TECHNICAL BULLETIN INDEX
Sorted by Bulletin Number
06/25/86

DATE: January 10, 1983
REVISION DATE: January 10, 1983
BULLETIN NO.: 12/16B:1
PRODUCT: 26-4004/5 (Model 12)
SUBASSEMBLY: Motorola Video Board

PURPOSE: To explain the differences between Motorola driver board used in the Model 16 and the version used in the Model 12.

Figure 1

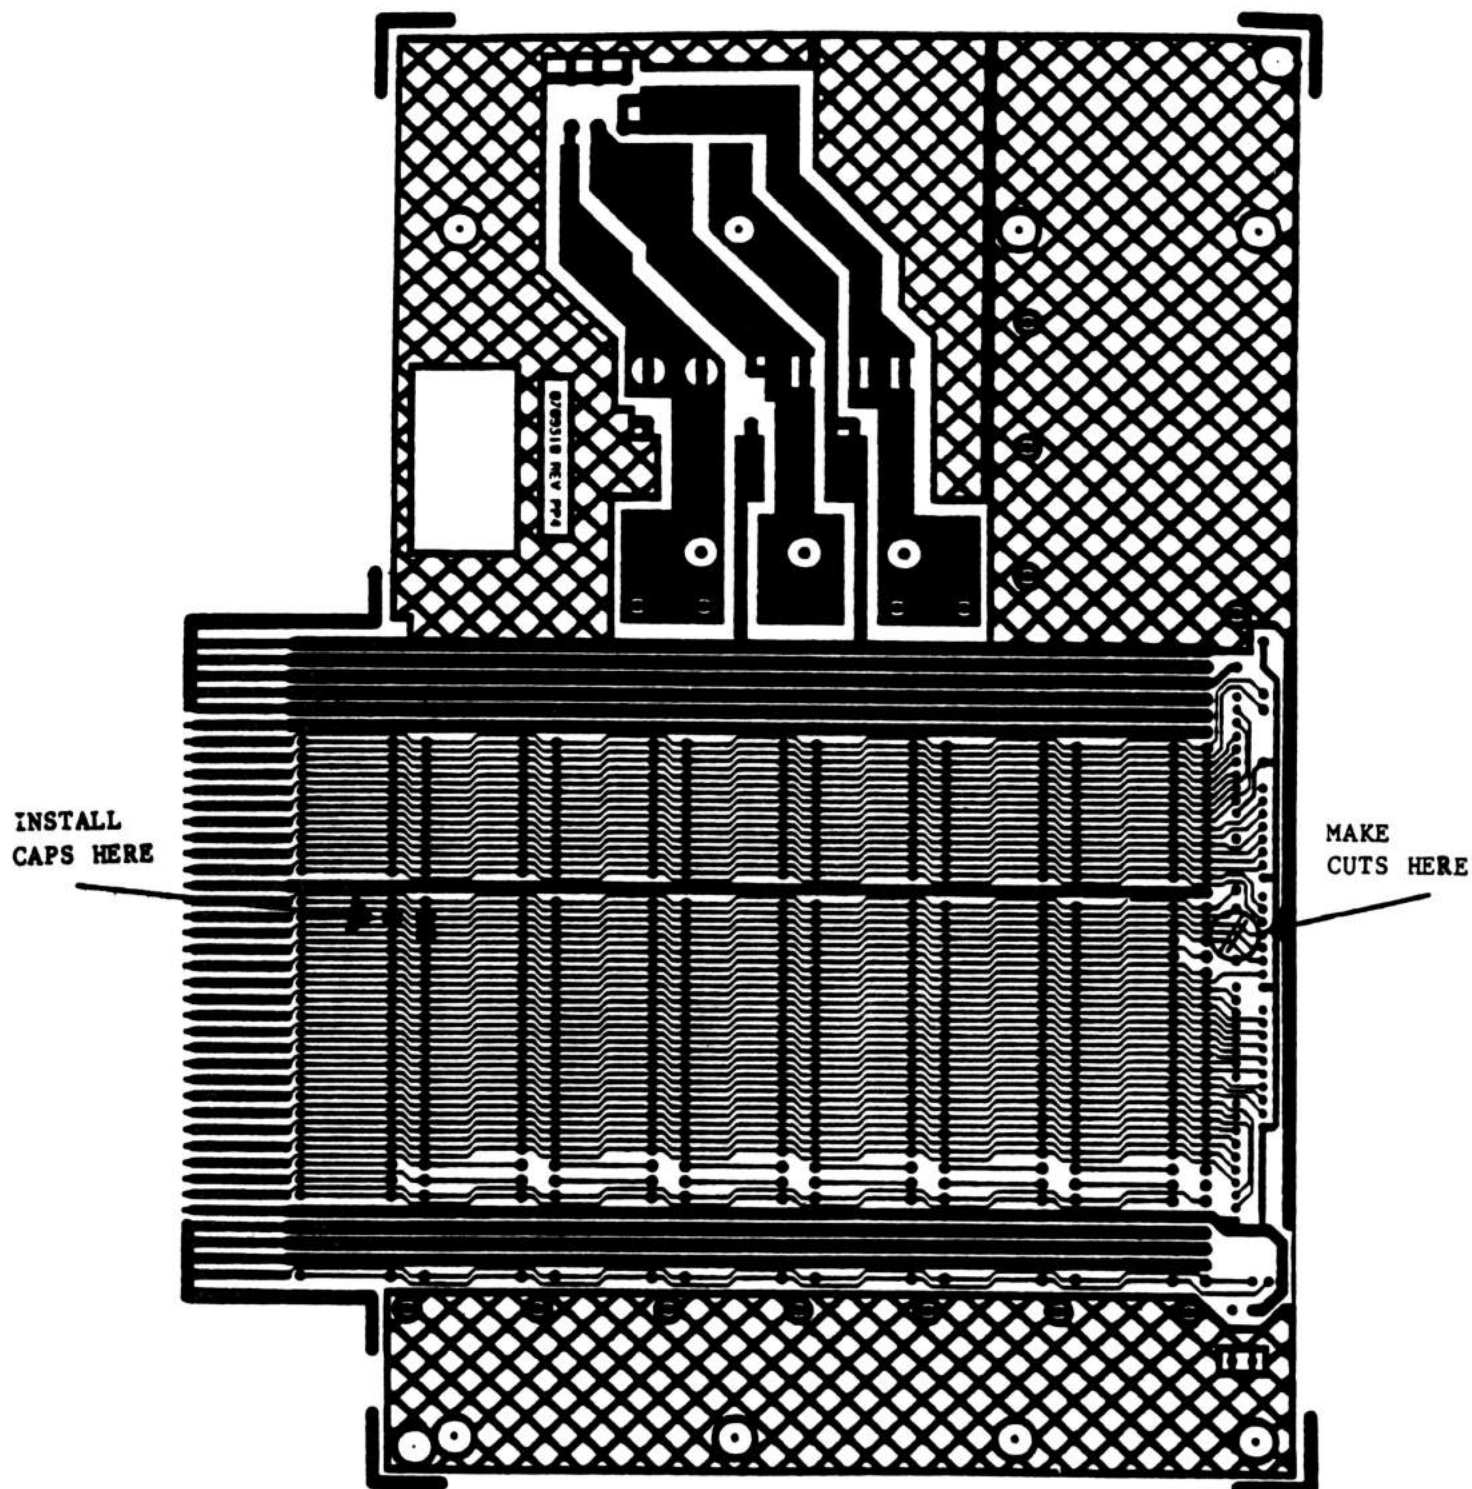
On mother boards of revision levels prior to Rev. B, pins 3, 4, and 5 on resistor pack R6 need to be cut.

On mother boards of revision level Rev. B or later, pins 4, 5, and 6 on resistor pack R6 need to be cut.

On boards of all revision levels, three (3) 220 pf caps should be jumpered from pins 44, 45, and 46 to ground on the bottom-most connector. These pins correspond to the traces cut on the resistor pack R6. See Figure 1 for clarification. The capacitors needed for this modification may be ordered as:
